CLASS II MODIFICATION 2019 - SUPPLEMENT
10/28/2019

Site Plan Supplement
Atlantic Crossing
Delray Beach
Florida

Drawing No.
SP-2B

Drawing No.
SP-3A

SITE PLAN

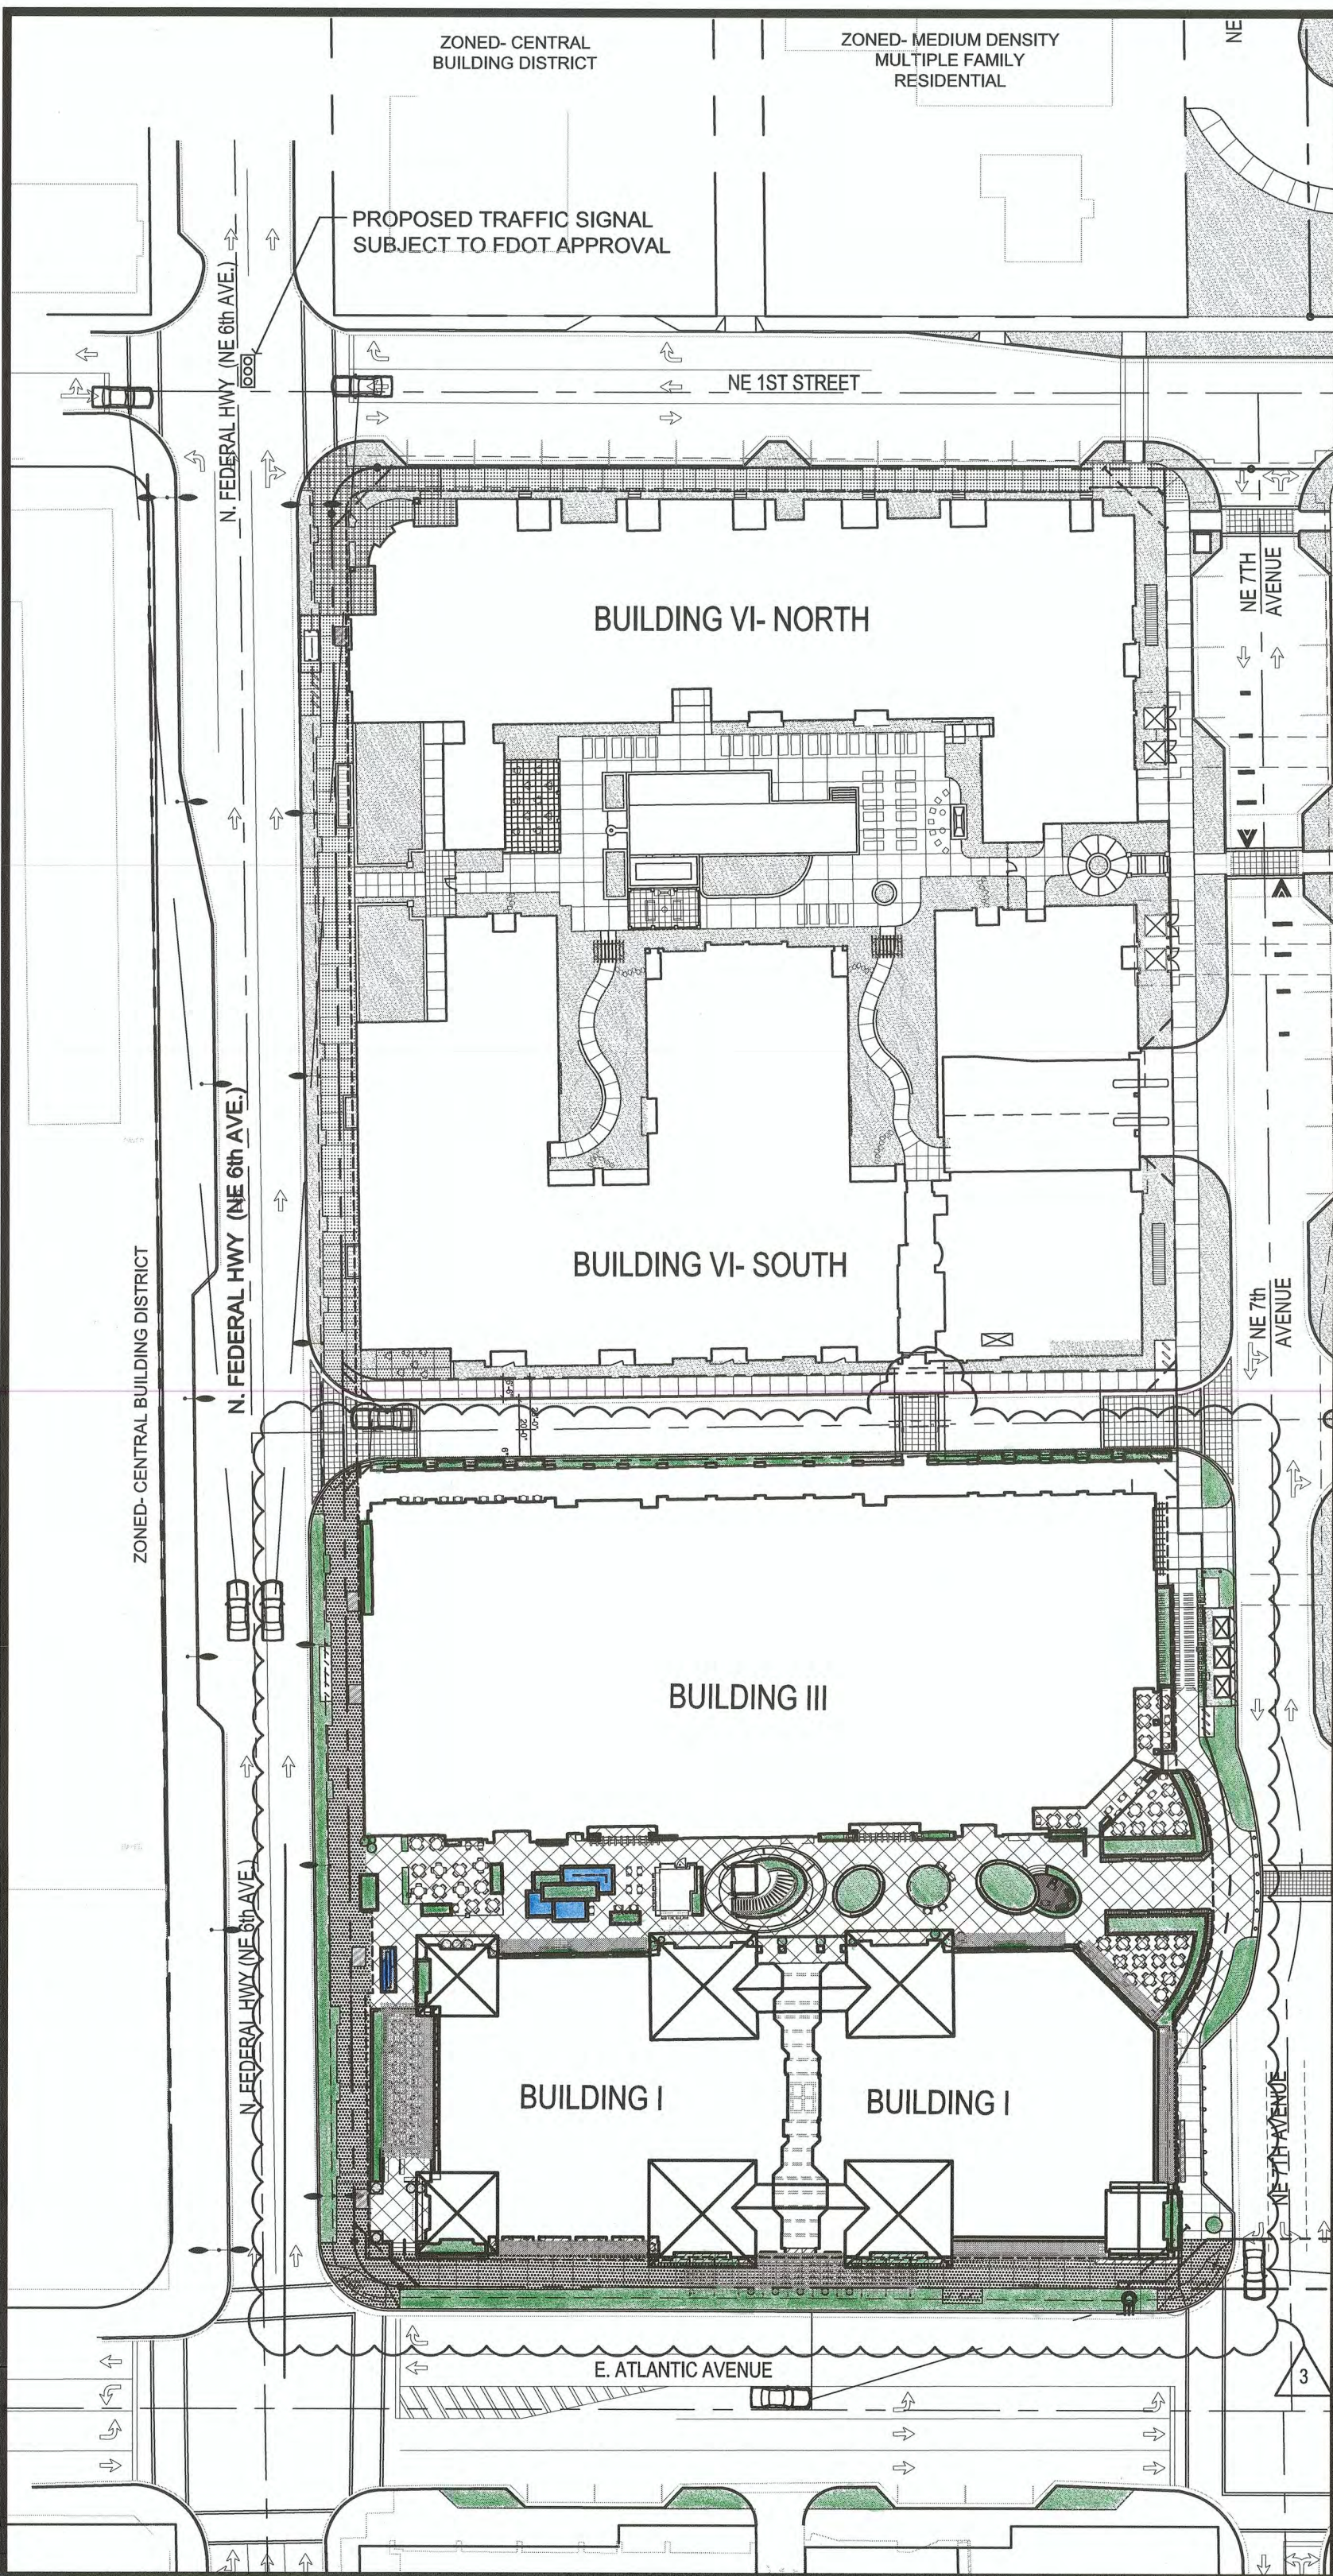
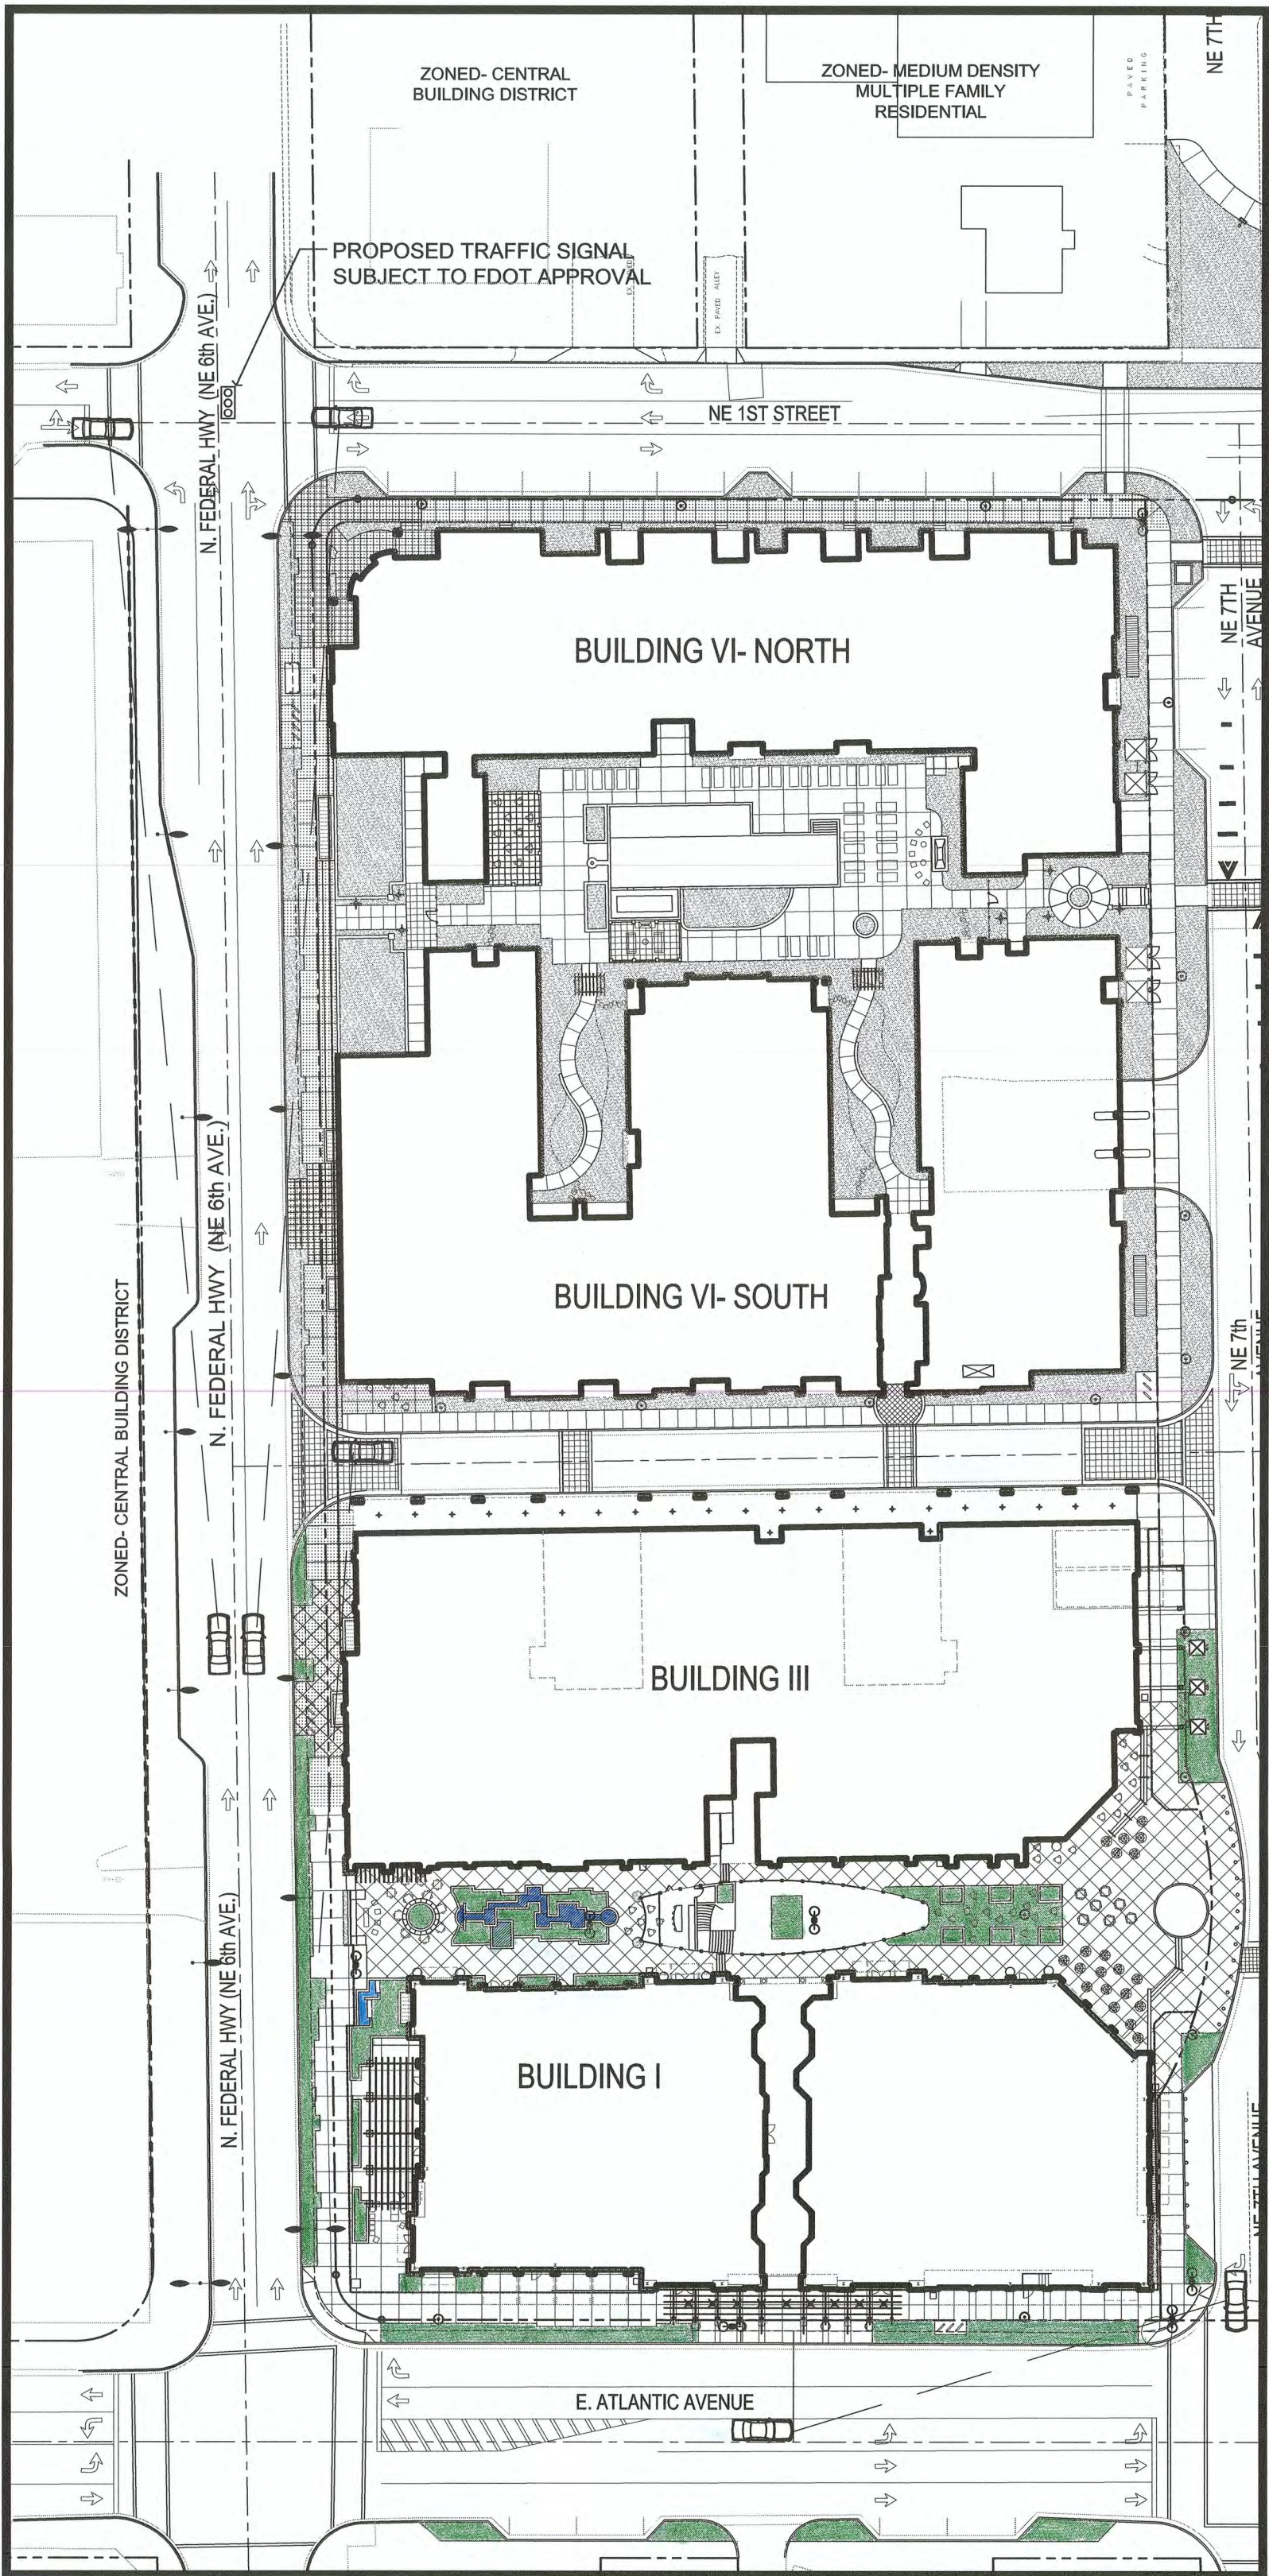
1. IMPROVED PEDESTRIAN ACCESS FROM NE 6TH AVE.
2. RESTAURANT SEATING NOW ENCLOSED PER LDR'S.
3. NEW FREE STANDING BAR BUILDING ENGAGES WATER FEATURE.
4. WATER FEATURE AT NW BUILDING I IS ENHANCED AND VIEWABLE FROM ALL SIDES.
5. IMPROVED AND INCREASED PEDESTRIAN FLOW ACROSS AND THROUGH COURTYARD TO ENHANCE RETAIL FUNCTION.
6. NAUTILUS WAS REPLACED WITH CANOPY MORE IN SCALE TO SPACE AND THE ECHELMAN SCULPTURE.
7. CENTER STEPS/RAMP REMOVED FOR BETTER PEDESTRIAN FLOW.
